From: Town Clerk
To: Maura Weissleder
Subject: FW: Opposition to the proposed cell tower at 62 Granite Springs Road
Date: Tuesday, March 3, 2026 3:25:37 PM

From: rapappas
Sent: Tuesday, March 3, 2026 3:17 PM
To: Town Clerk <townclerk@yorktownny.gov>; Ed Lachterman <elachterman@yorktownny.gov>; Patrick Murphy <pmurphy@yorktownny.gov>; Sergio Esposito <sesposito@yorktownny.gov>; Susan Siegel <ssiegel@yorktownny.gov>; Ilan Gilbert <igilbert@yorktownny.gov>
Cc: nocelltoweryorktown@yahoo.com
Subject: Opposition to the proposed cell tower at 62 Granite Springs Road

3/3/26
RE: Opposition to the proposed cell tower at 62 Granite Springs Road
Dear Town Board Members,
I write in opposition to the construction of a 130-foot macro cell tower at 62 Granite Springs Road.
The developer has not established that there is a significant gap in cellular service in the area. To the extent there is a gap, the Cityscape report recommendation is that one “small cell” be placed on an existing utility pole. A macro cell tower is not recommended.
Further, the proposed plan would have drastic negative environmental effects. The proposed site is directly adjacent to Stuart’s Fruit Farm - the oldest working f

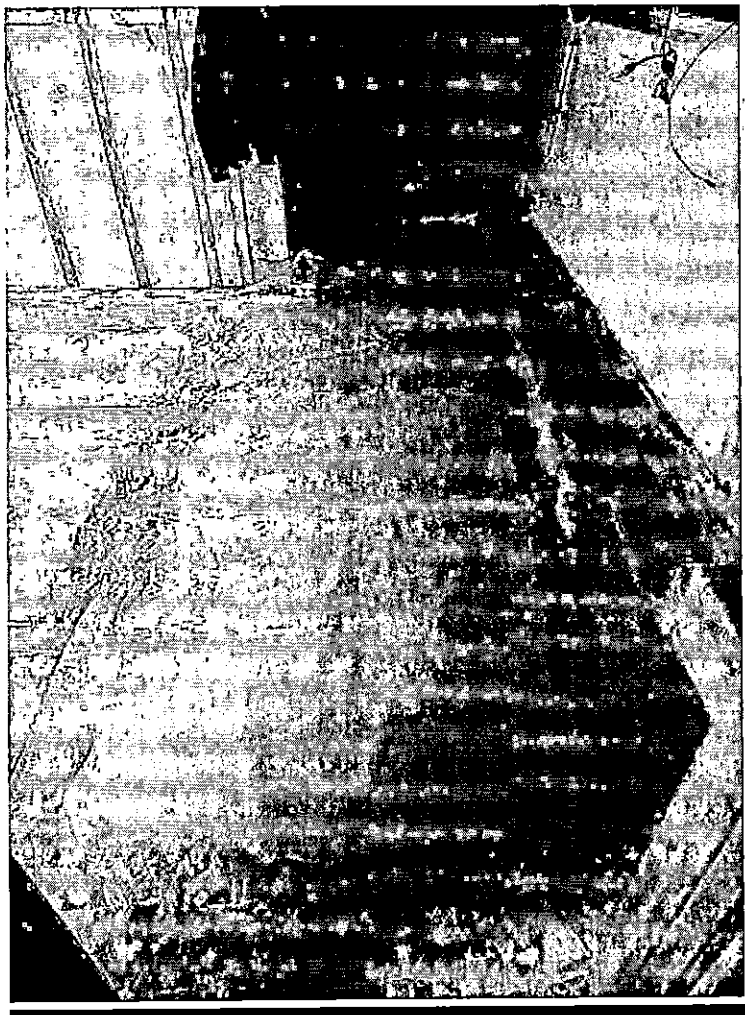
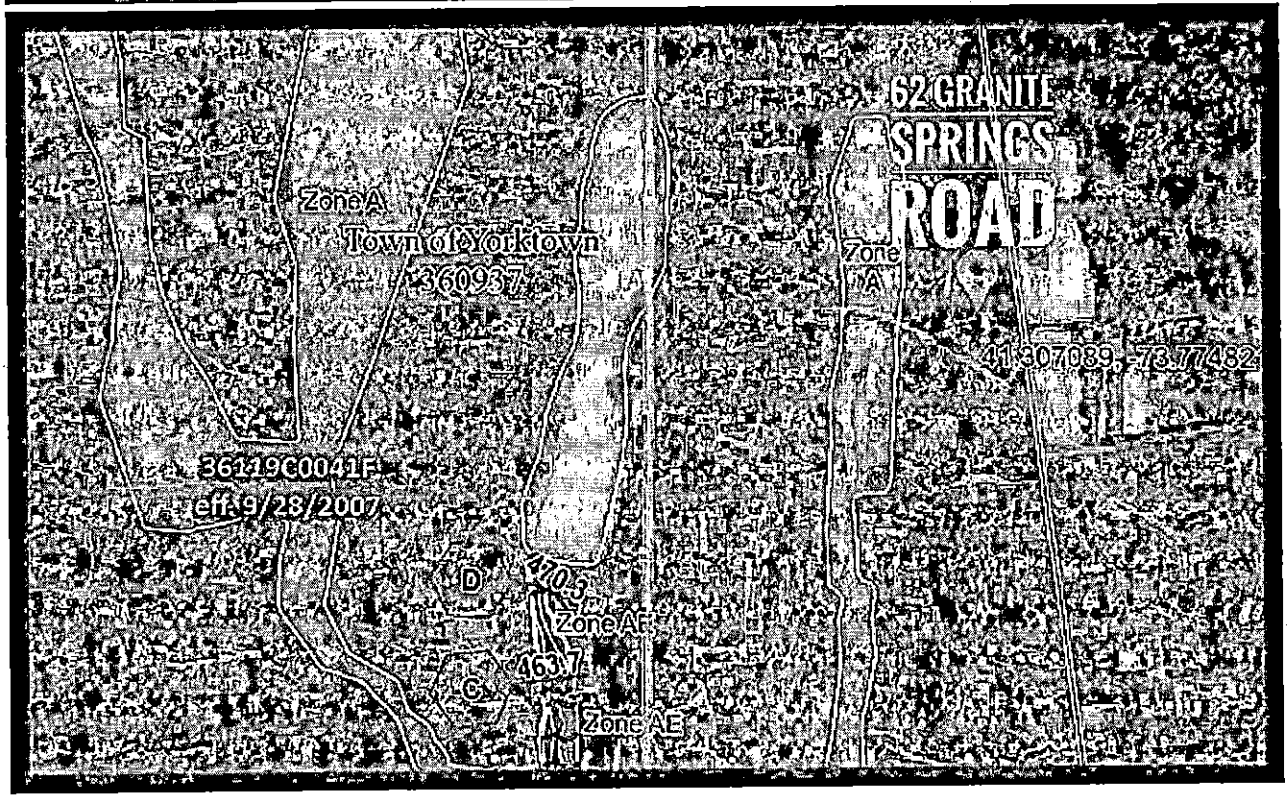
We are including 3 photos of our 8 foot full basement that the rising water table has impacted our home, walls, floors and foundation. One picture is worth a 1000 words after living in our house for over 60 years with a full finished basement which never had any water issues previously. Which proves the water tables have risen in the area. We recently spent over $20,000 to install French foundation drains and a new concrete floor. Also included is the photo of FEMA flood map of the area with elevations that show this is an low elevation area.

Proper management requires subsurface foundation testing down to the bedrock if present and this has not been done on this project. For these reasons, I strongly urge the Town to halt this project immediately. Please add our letter to the testimony on-line.

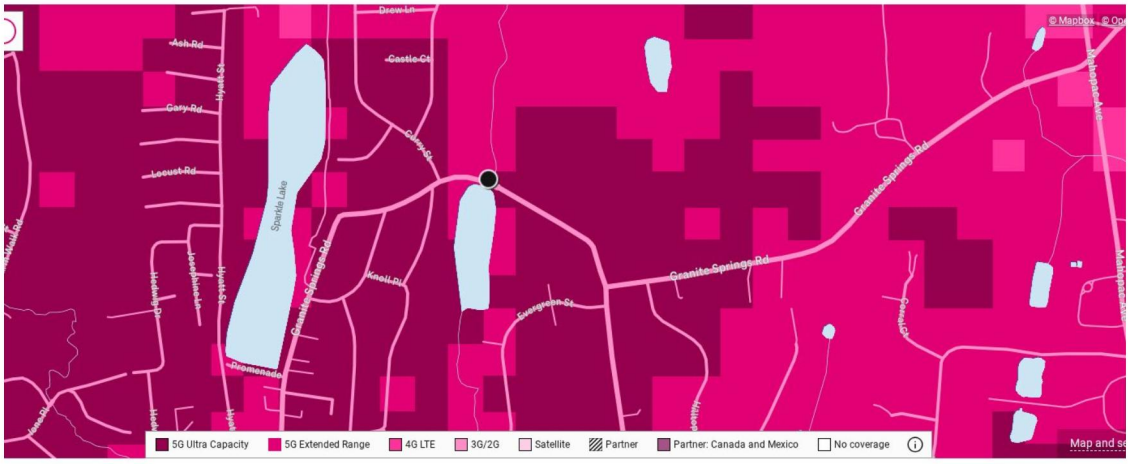
The figure below is a screenshot from T-Mobile's website of coverage at the proposed site with the proposed site being represented by the black dot (Footnote 6). Again, you can plainly see there is no lack of cellular coverage.

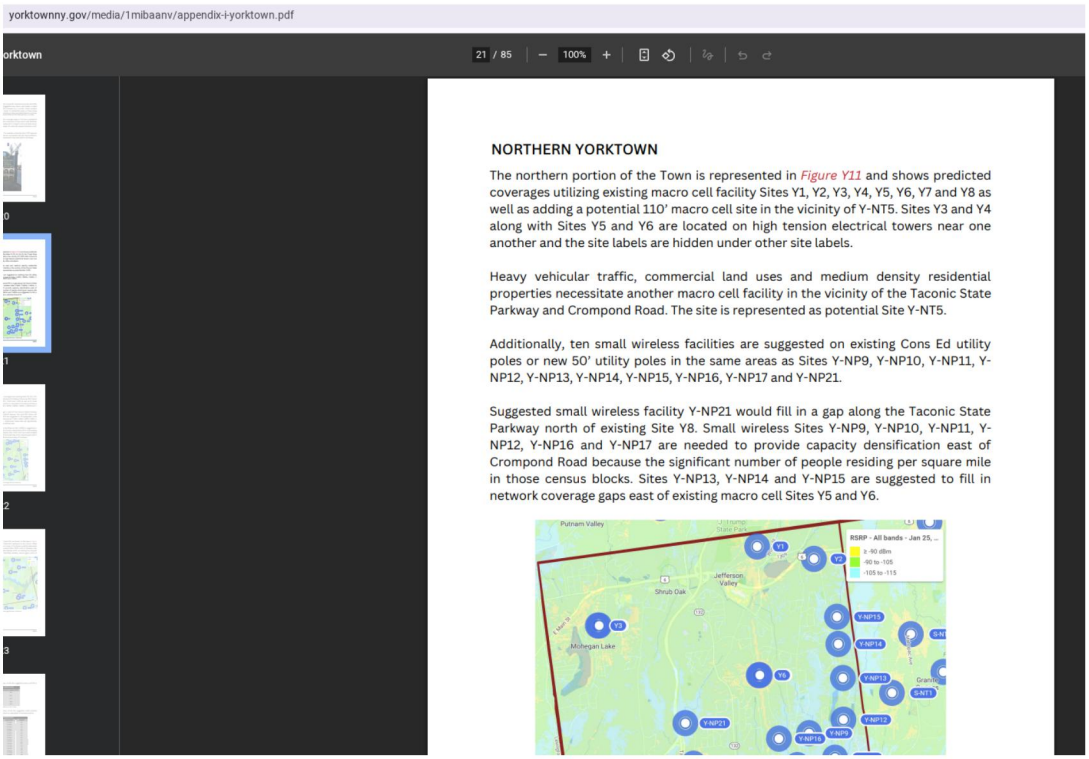
Below is a screenshot of the Cityscape Report's recommendations for the proposed site.

As I explained in my letter yesterday, The location where the applicant wants to build a macro cell tower is identified in Figure Y11 on page 121 as Site Y-NP12 and the recommendation for that location is a small cell.

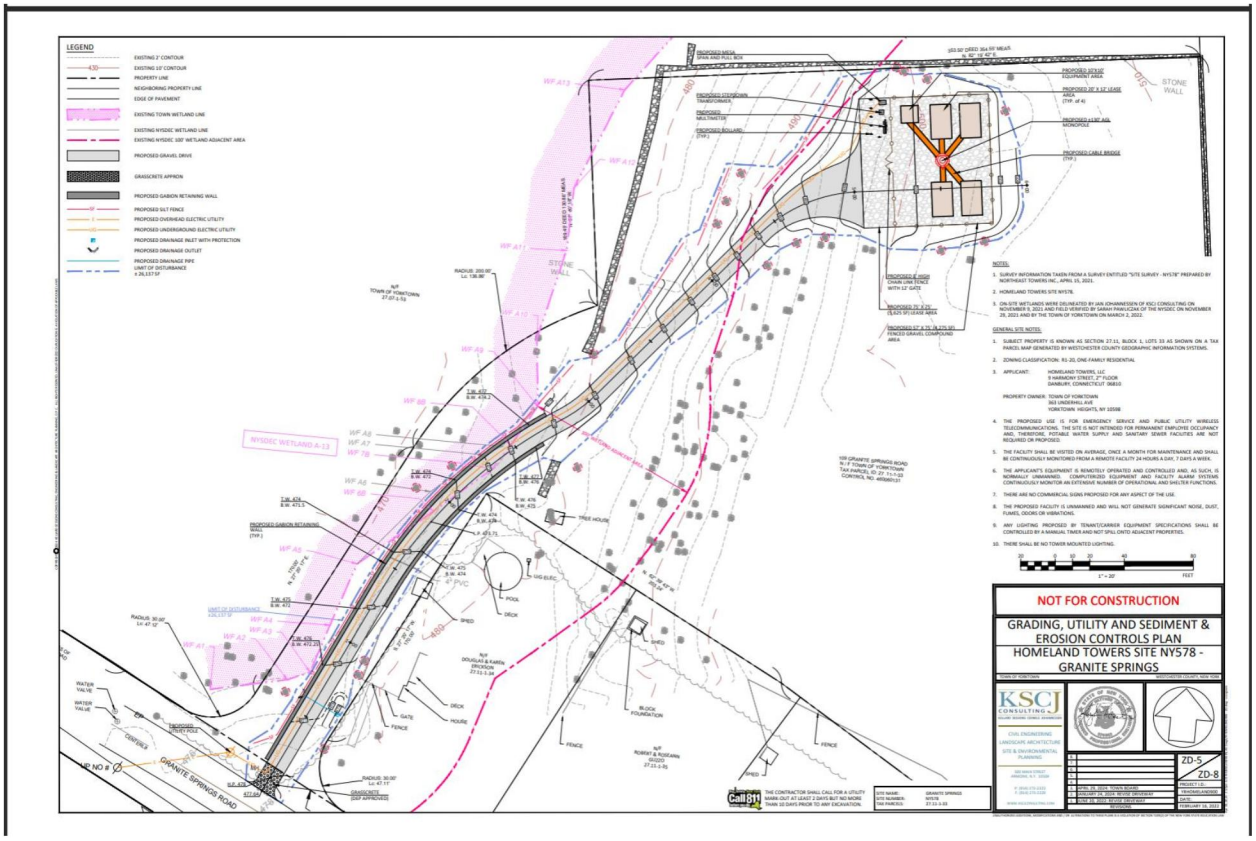
The May 2024 site plan is below. As you can see it shows both the NYSDEC wetland delineation and the field adjusted wetland line from Johanna Duffy from Barton and Loguidice which was done with the applicant's consultant present. The field adjusted wetland line clearly crosses almost ⅔ of the driveway. The driveway is also directly adjacent to our property line.

Figure Y11: Predicted LTE Coverage Northern Yorktown

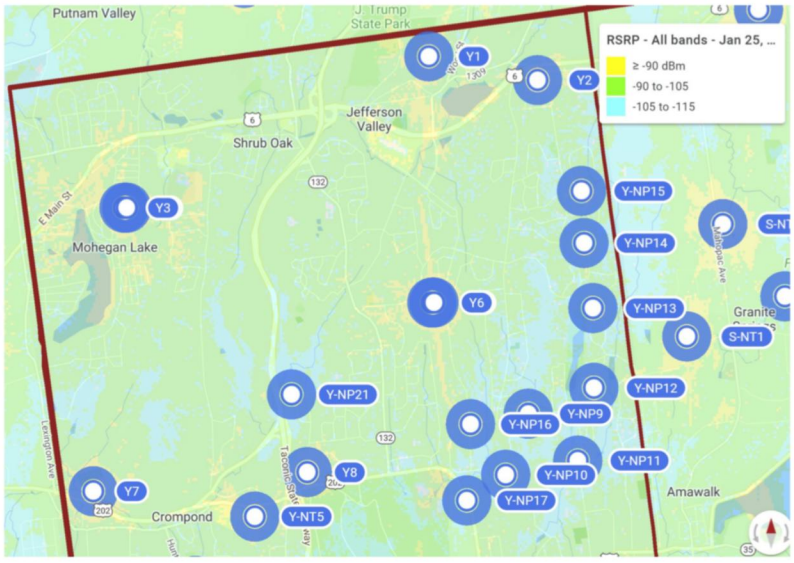
The second reason the applicant's reliance on the Cityscape Report is misplaced is that **the Cityscape Report does not recommend a macro cell tower at this location**. The Yorktown appendix of the Cityscape Report is not on the Town's webpage for this project, although I strongly believe it should be, as it has been repeatedly used to justify the construction of this tower. Page 121 of the Cityscape Report includes the recommendations for the proposed site. The location where the applicant wants to build a macro cell tower is identified in Figure Y11 on page 121 as Site Y-NP12 (Footnote 3). The Cityscape Report states that "ten small wireless facilities are suggested on existing Cons Ed utility poles or new 50' utility poles in the same areas as Sites Y-NP9, Y-NP10, Y-NP11, YNP12, Y-NP13, Y-NP14, Y-NP15, Y-NP16, Y-NP17 and Y-NP21." The Cityscape Report goes on to state that "small wireless Sites Y-NP9, Y-NP10, Y-NP11, YNP12, Y-NP16 and Y-NP17 are needed to provide capacity densification east of Crompond Road because the significant number of people residing per square mile in those census blocks." Further, the Cityscape Report recommends only one macro cell facility in the northern part of town, to be placed in the vicinity of the Taconic State Parkway and Crompond Road, on the site represented as potential Site Y-NT5 in Figure Y11 on Page 121.

3- If that is unclear from Figure Y11 on page 121 because blue shading is used, you can verify this by looking at any of the other figures within the Cityscape Plan. For example, you can compare Figure Y1 on Page 5 to Figure Y11 on page 121 and clearly see that the site of the proposed tower is represented by Site Y-NP12 on Page 121.

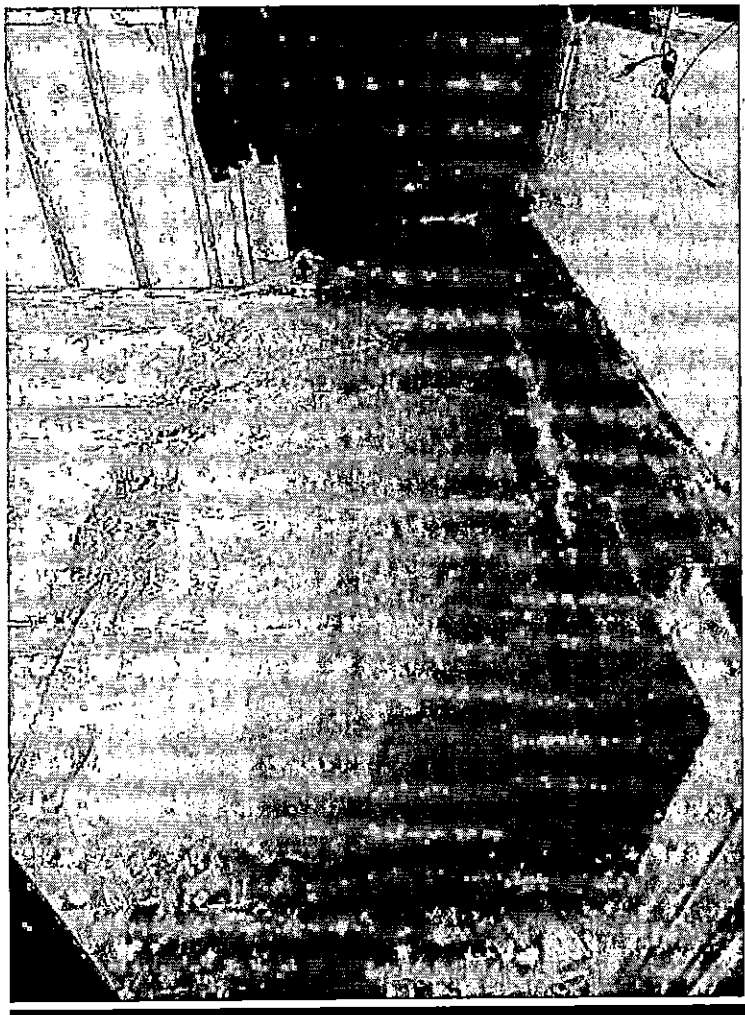
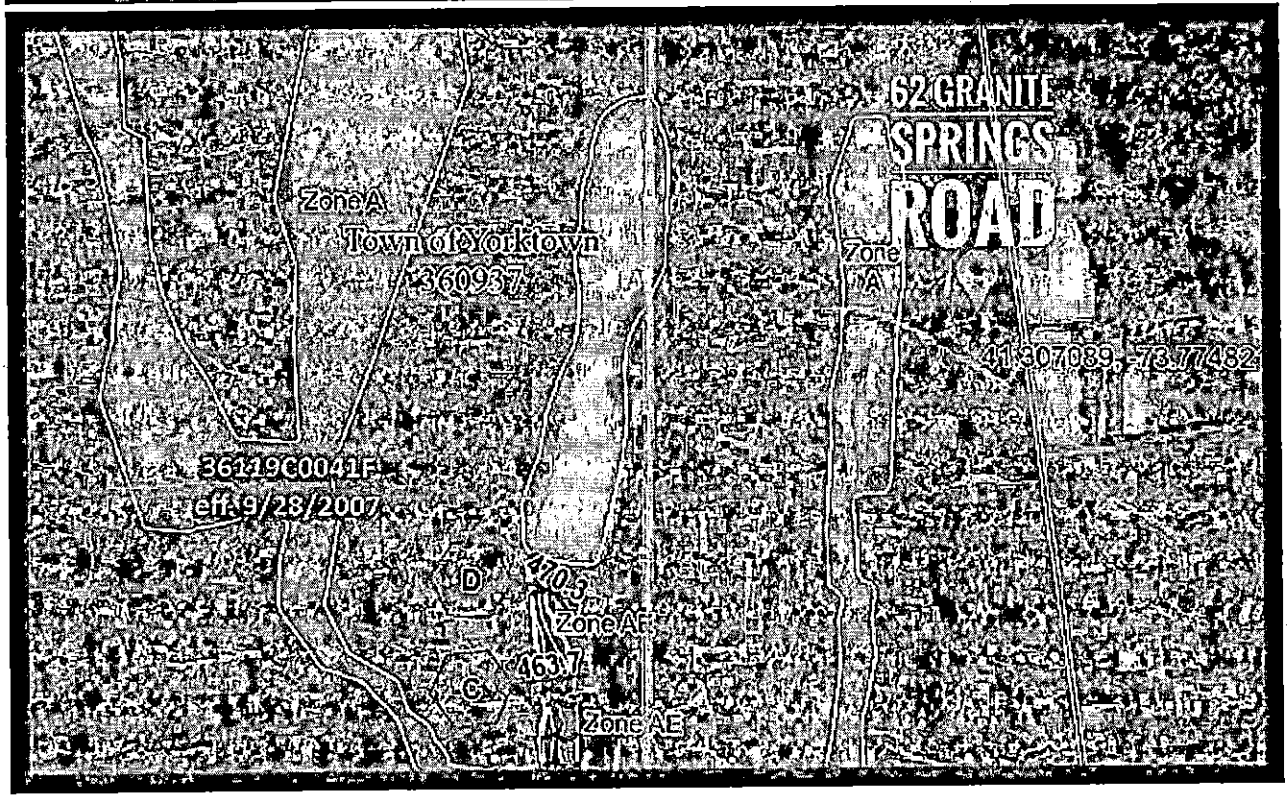
We are including 3 photos of our 8 foot full basement that the rising water table has impacted our home, walls, floors and foundation. One picture is worth a 1000 words after living in our house for over 60 years with a full finished basement which never had any water issues previously. Which proves the water tables have risen in the area. We recently spent over $20,000 to install French foundation drains and a new concrete floor. Also included is the photo of FEMA flood map of the area with elevations that show this is an low elevation area.

Proper management requires subsurface foundation testing down to the bedrock if present and this has not been done on this project. For these reasons, I strongly urge the Town to halt this project immediately. Please add our letter to the testimony on-line.

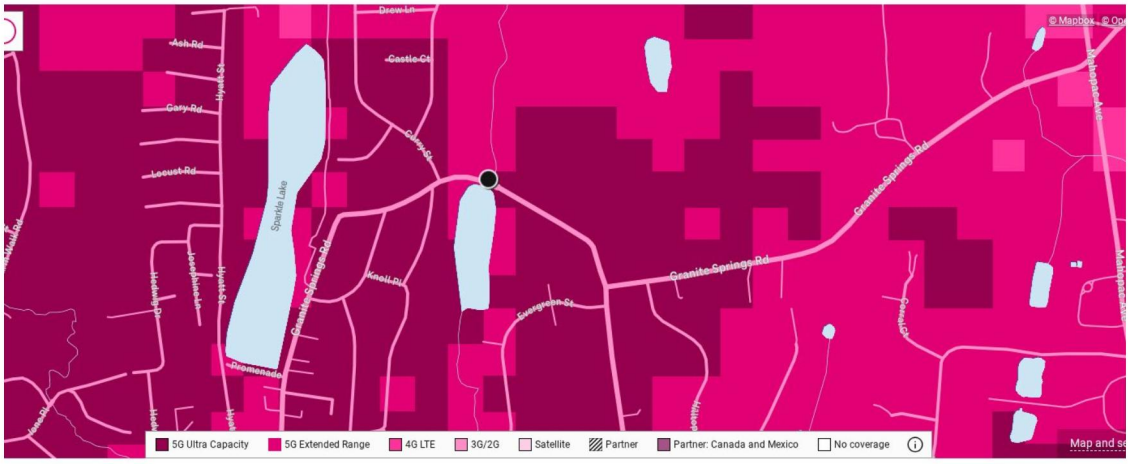
The figure below is a screenshot from T-Mobile's website of coverage at the proposed site with the proposed site being represented by the black dot (Footnote 6). Again, you can plainly see there is no lack of cellular coverage.

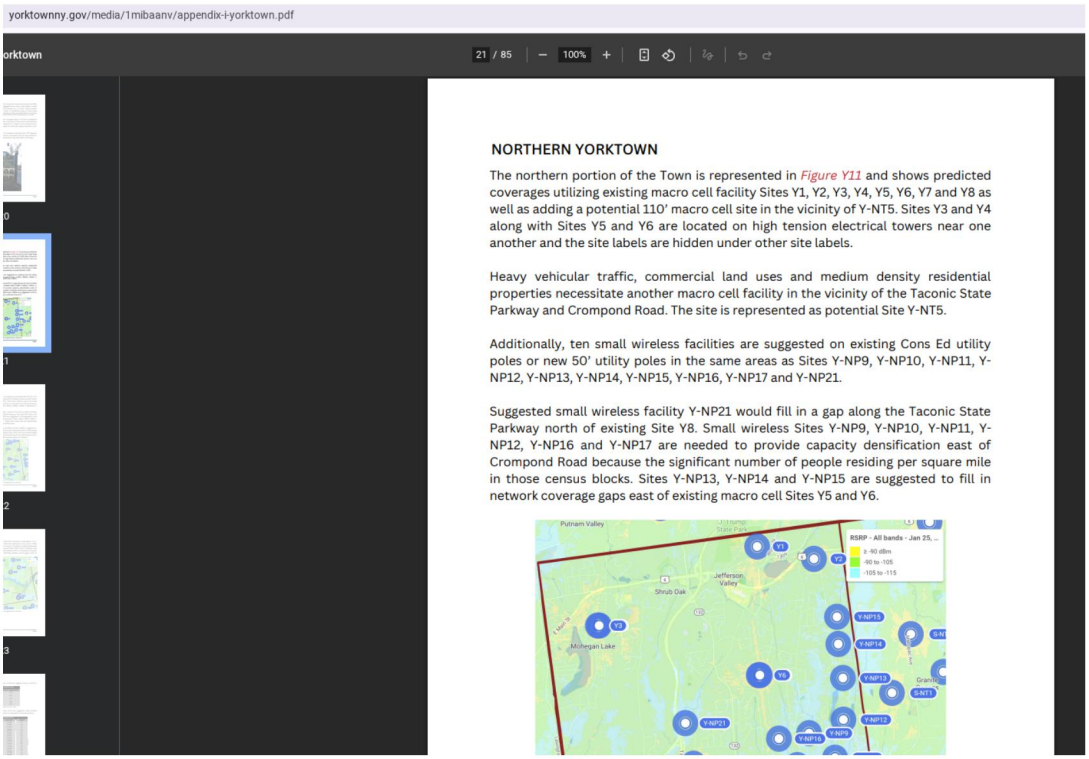
Below is a screenshot of the Cityscape Report's recommendations for the proposed site.

As I explained in my letter yesterday, The location where the applicant wants to build a macro cell tower is identified in Figure Y11 on page 121 as Site Y-NP12 and the recommendation for that location is a small cell.

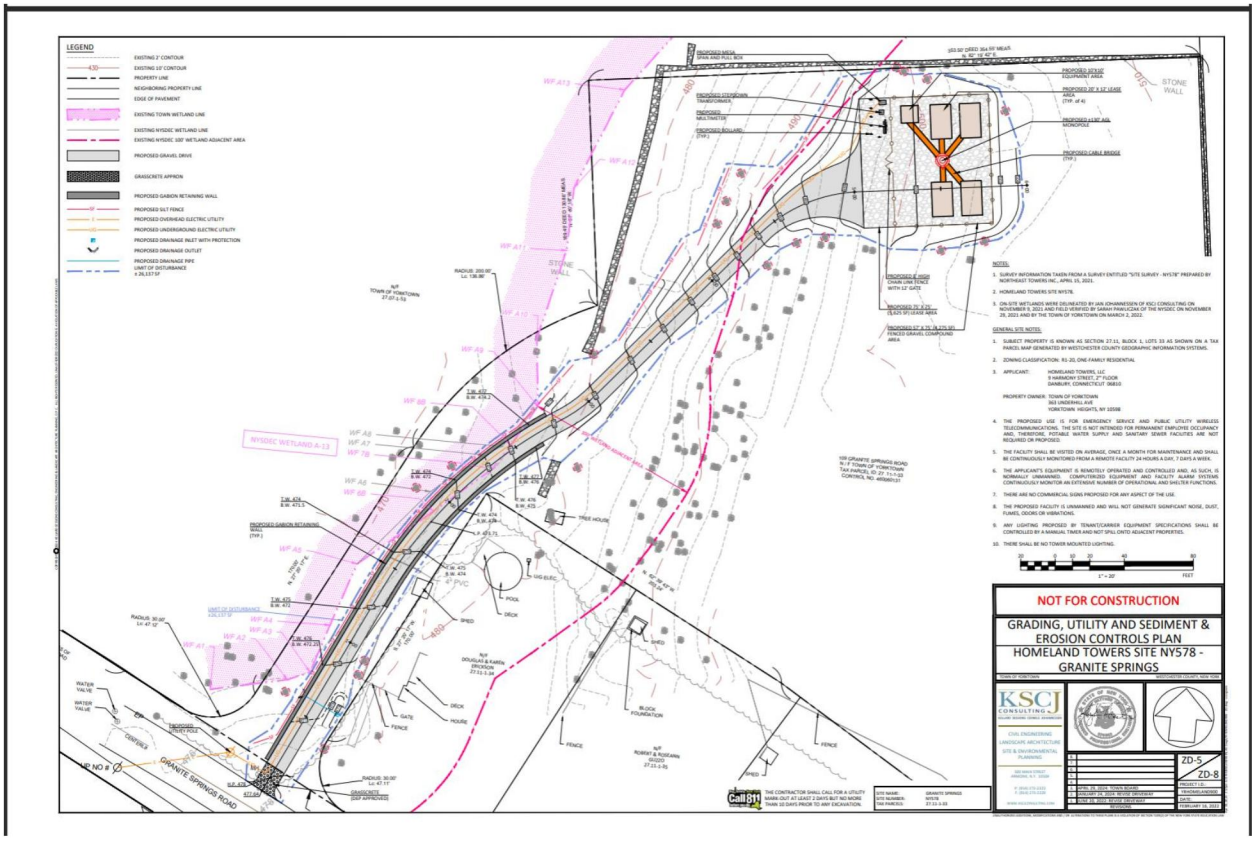
The May 2024 site plan is below. As you can see it shows both the NYSDEC wetland delineation and the field adjusted wetland line from Johanna Duffy from Barton and Loguidice which was done with the applicant's consultant present. The field adjusted wetland line clearly crosses almost ⅔ of the driveway. The driveway is also directly adjacent to our property line.
